ADDENDUM 4

ITB AP 59-20

CONSTRUCT BAGGAGE HANDLING SYSTEM AND WEST TERMINAL EXPANSION – DESTIN-FORT WALTON BEACH AIRPORT (VPS)

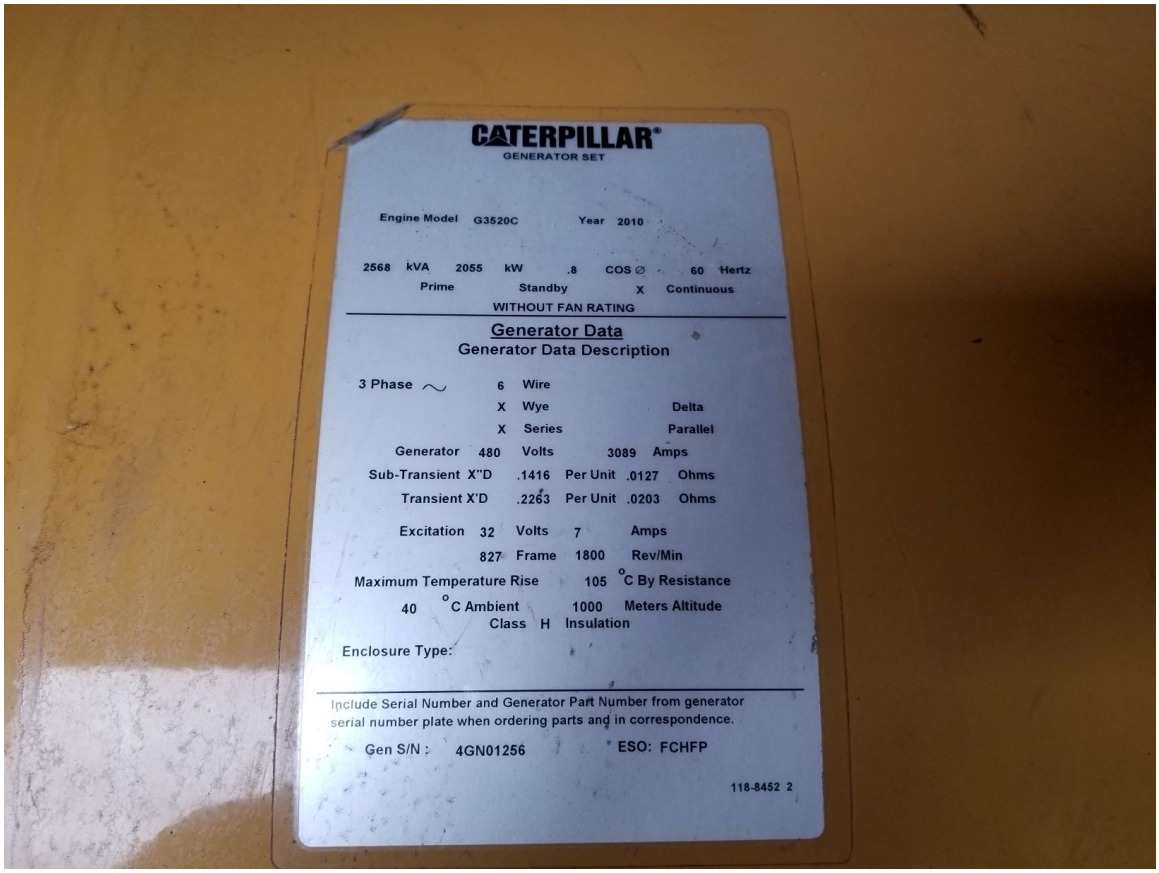
6. The previous addendum had a question that asked about the generator manufacture and type. Could you provide the name tag information on the generator set if it is accessible so we could have more information regarding the size?

Answer: See images below of existing generator nameplates.

S0-003

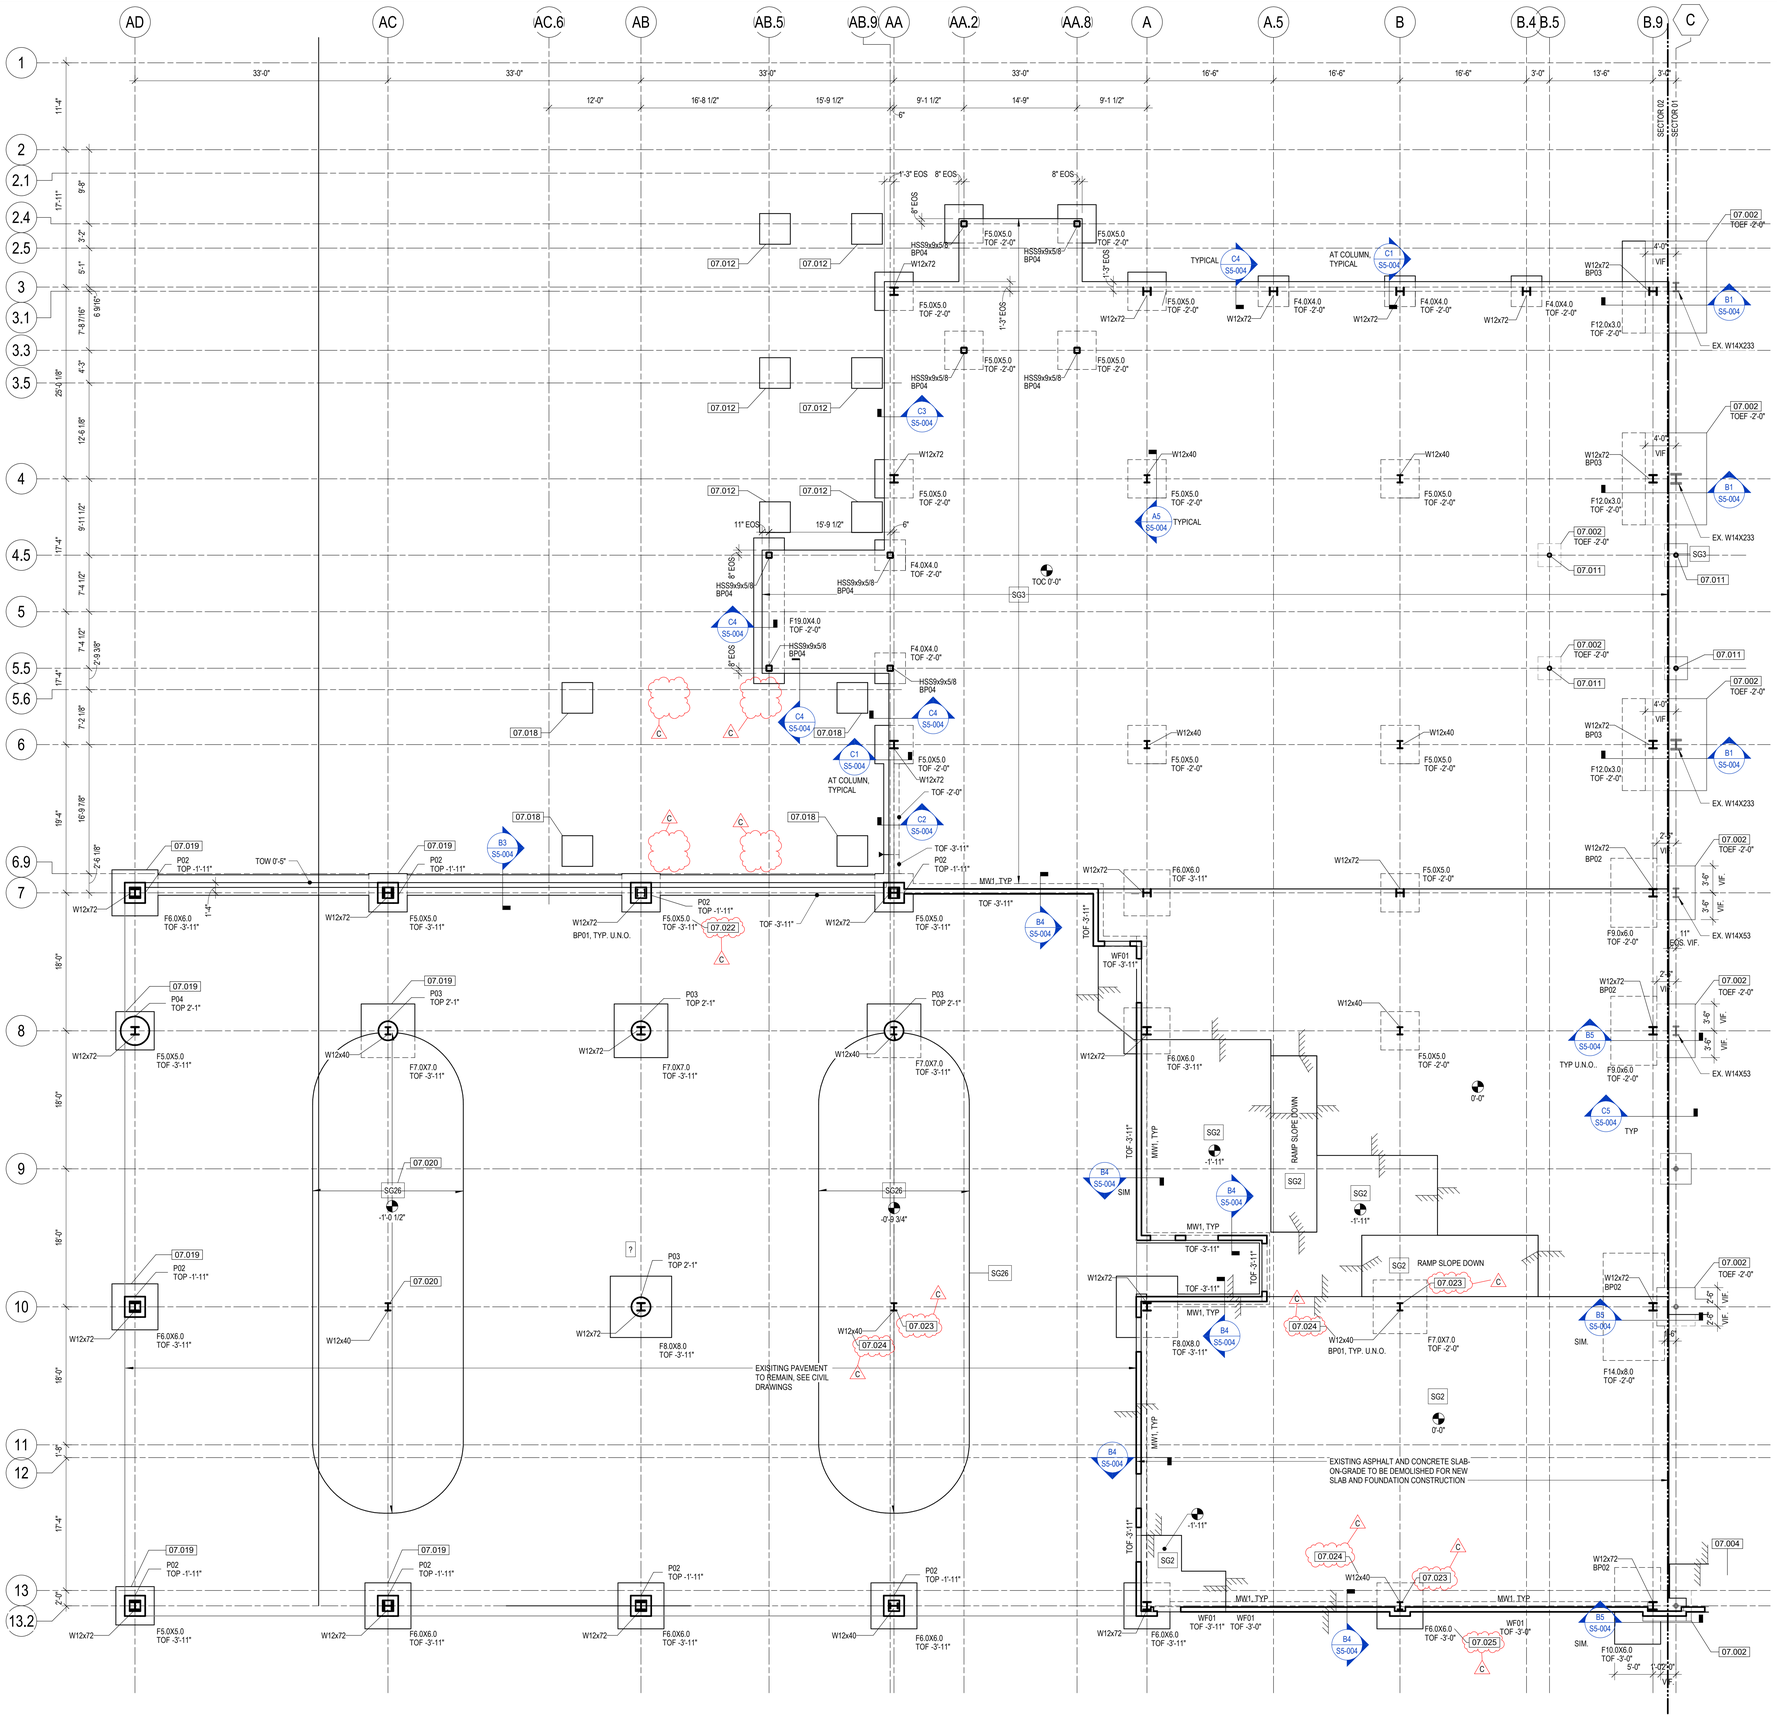
21. Sheet S0-003 – Part 3 Paragraph 3.1.A Testing Agency shall be retained by the Owner….; Part 1 paragraph 1.1.B. – Owner to retain a special inspector…; Section 014500 Paragraph 1.2.A.2. "Inspection and testing services….are to be provided by the owner…"; Section 014529 Paragraph 1.3.A. states "The contractor shall engage a separate agency to serve as a Threshold Inspector.." Please clarify the conflicts in the specifications and the Special Inspection Notes on the Plans. Who provides the testing & inspection cost?

Answer: Section 014529 shall be used to determine who provides testing and inspection costs. Sheet S0-003 has been revised.

S6-001

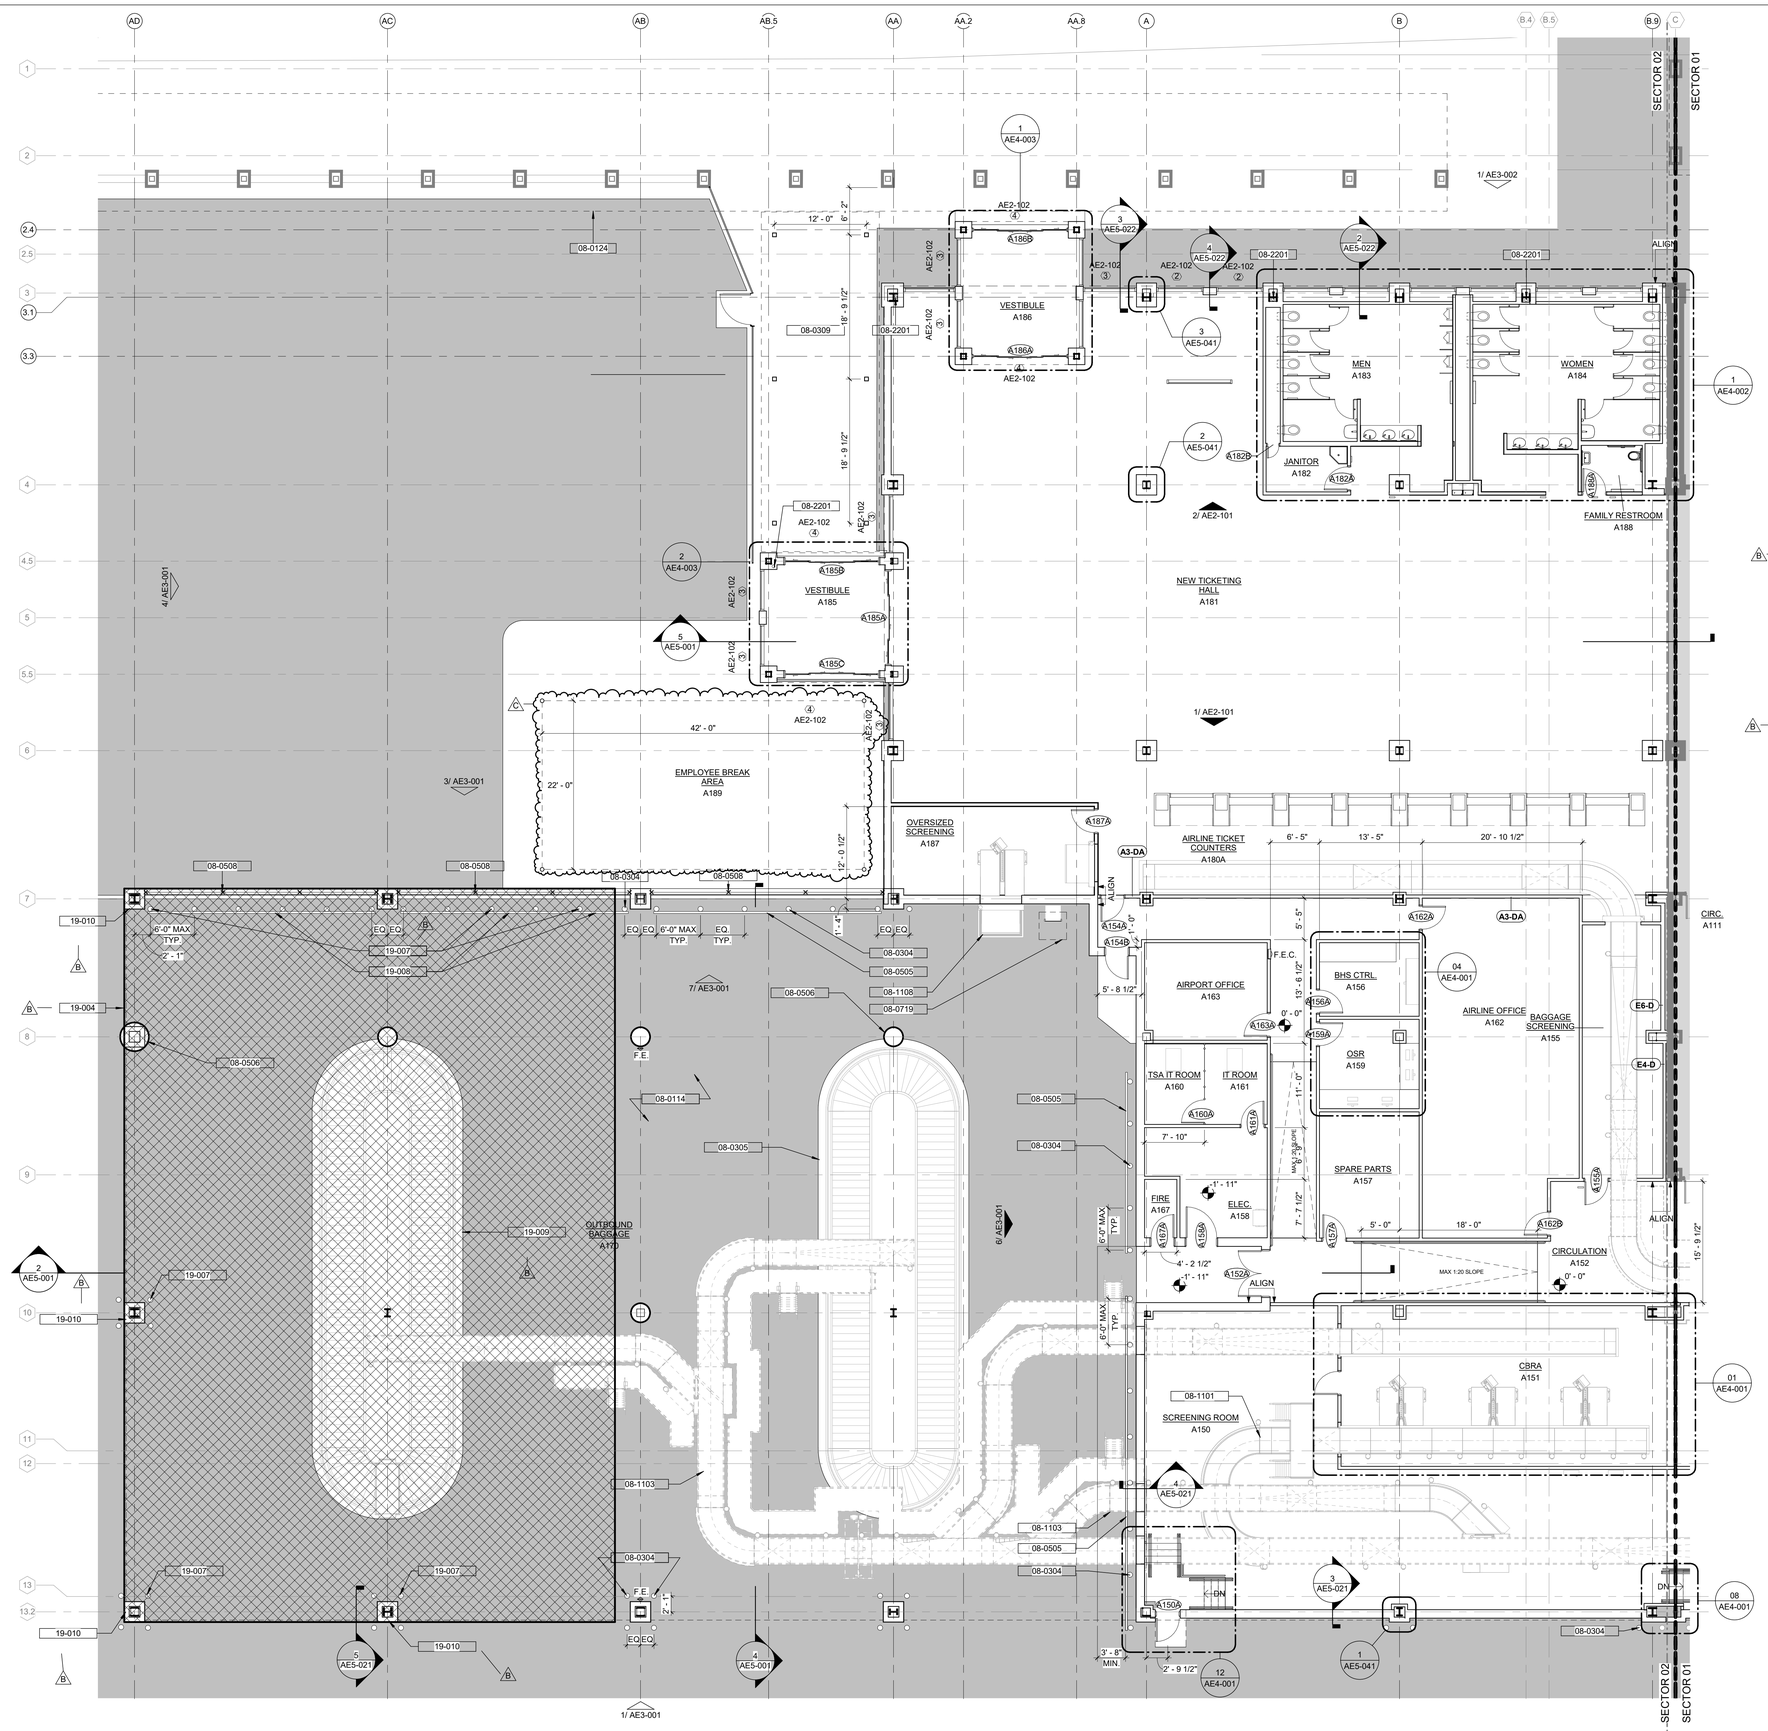
18. Sheet AE1-102 Keynote 08-0506 calls for steel column protection painted safety yellow-refer to structural. There is no detail on the structural drawings for this column protection. The applicable columns sit on piers that extend 4' above the top of slab. Please request detail from Arch/Eng. for this giving the extent of guard, thickness of material and anchorage to pier.

Answer: Detail added to Sheet S6-001.

AE1-102

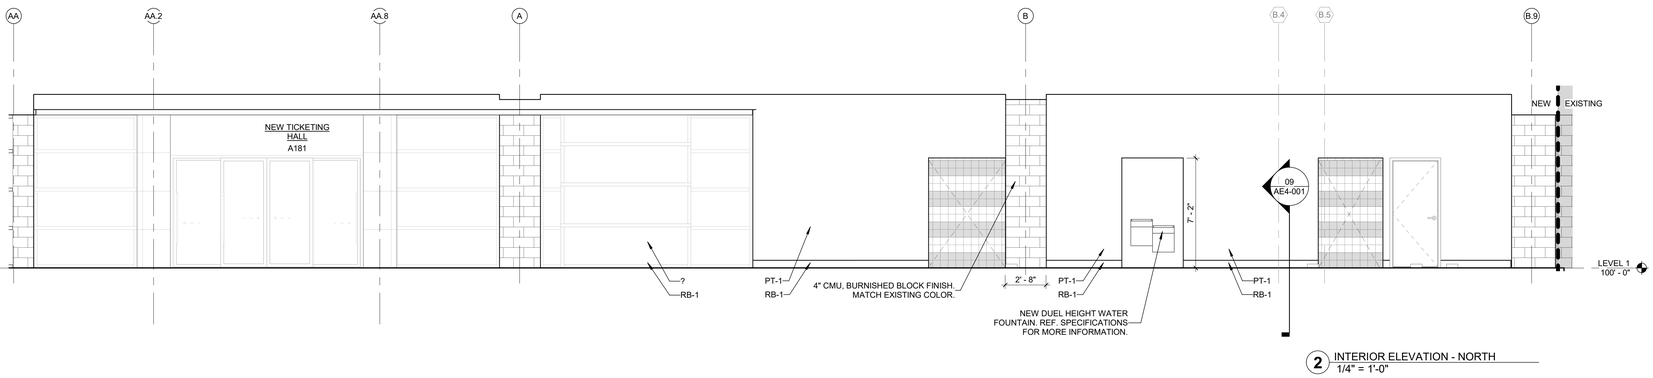
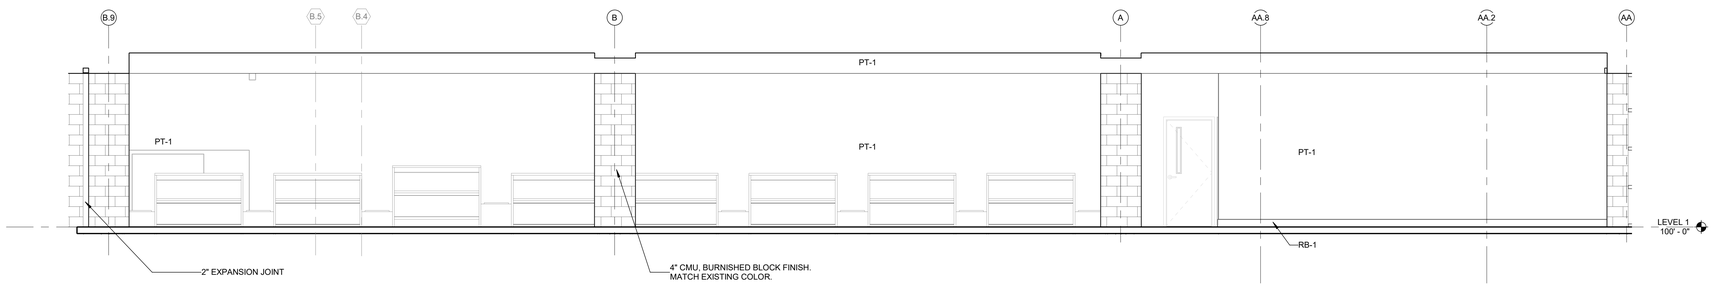
28. In the Pre-Bid, there was a lot of discussion about a fabric shade structure over the Employee Break Area A189. It is not shown on the drawings. Please provide a drawing showing the size and shape of the Shade Structure. The power point rendering shows 4 post; Sheet S1-102 shows locations for 8 post foundations (see keynote 07.018); Sheet AE1-102 shows locations for 6 post. Please provide clarification of what the shade structure is to look like. Size appears to be 26' x 42' per the Pre Bid Power Point. Please clarify.
Answer: Sheet AE1-102 will be revised to show 4 posts and indicate size.

2 ACCESSORIES PLAN
1/4" = 1'-0"

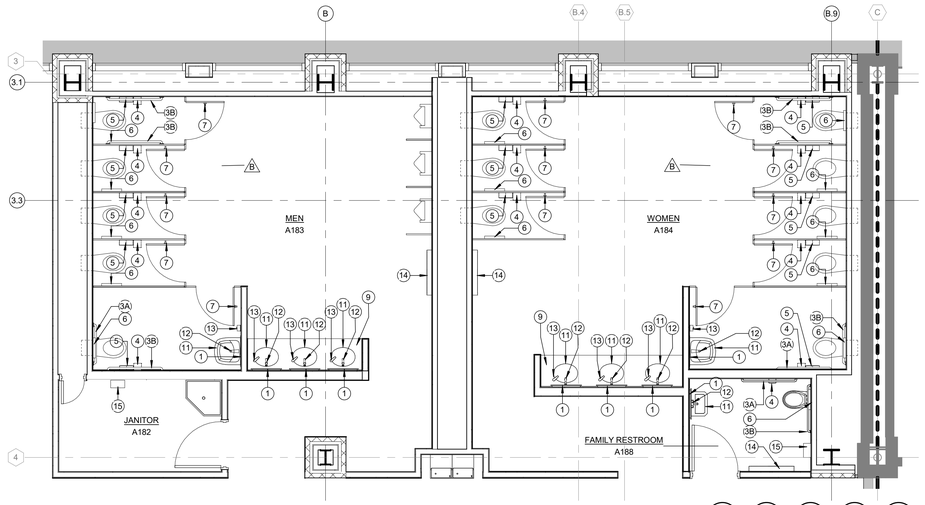
61. Sheet AE4-002 - Toilet Accessory Legend – Items 2 is not shown on the enlarged plans. Are they required?
Answer: Yes, AE4-002 has been revised to include.

62. Sheet AE4-002 - Accessory Plan – Item 1, 2, 6, 13, 14 are not shown in Room A188. Are they required?
Answer: Items 1, 6, 13, and 14 are required. Sheet AE4-002 has been revised to include.
